Re: Victorville 2 Hybrid Power Project, 07-AFC-1

The Application for Certification
for the VICTORVILLE 2 HYBRID
POWER PROJECT

CALIFORNIA UNIONS FOR RELIABLE ENERGY DATA REQUESTS, SET TWO

Figure 1

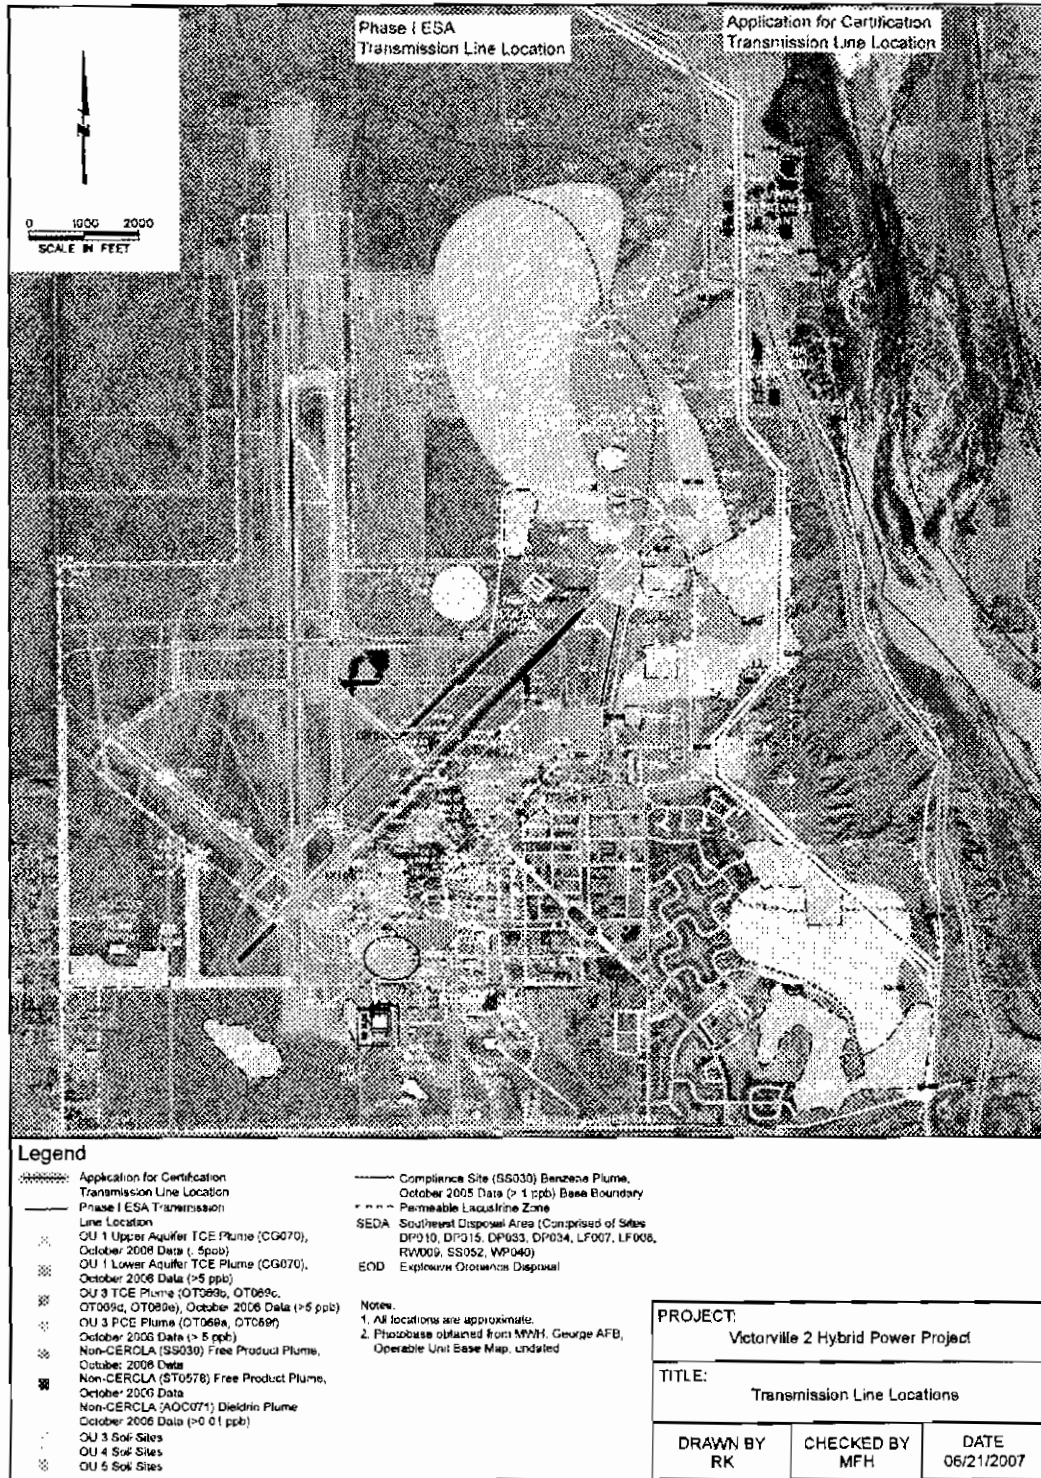
U.S. EPA Superfund National Priorities List.¹⁷⁴ In that connection, the U.S. Air Force signed a federal facilities agreement (FFA) with the U.S. EPA Region 9, the California Department of Health Services, and the California Regional Water Quality Control Board in 1990. The FFA established a plan for ongoing environmental assessment, remediation and restoration activities at the base. (See Figure 1, below).

145. Please clarify whether the transmission lines, including construction of access roads and support structures, will impact areas of soil and groundwater contamination as identified in Figure 1, including:

that is depicted in AFC Figure 2-1 to be located within 500 feet of 3 extraction wells (see Figure 1, below).

150. Please discuss whether groundwater monitoring wells, installed to determine if contamination is present at specific locations in aquifers impacted by former operations at George AFB, will be destroyed by transmission line construction activities. For example, we have mapped (in green) the route of the transmission line that is depicted in AFC Figure 2-1 to be located within 500 feet of 10 groundwater monitoring wells (Figure 1).
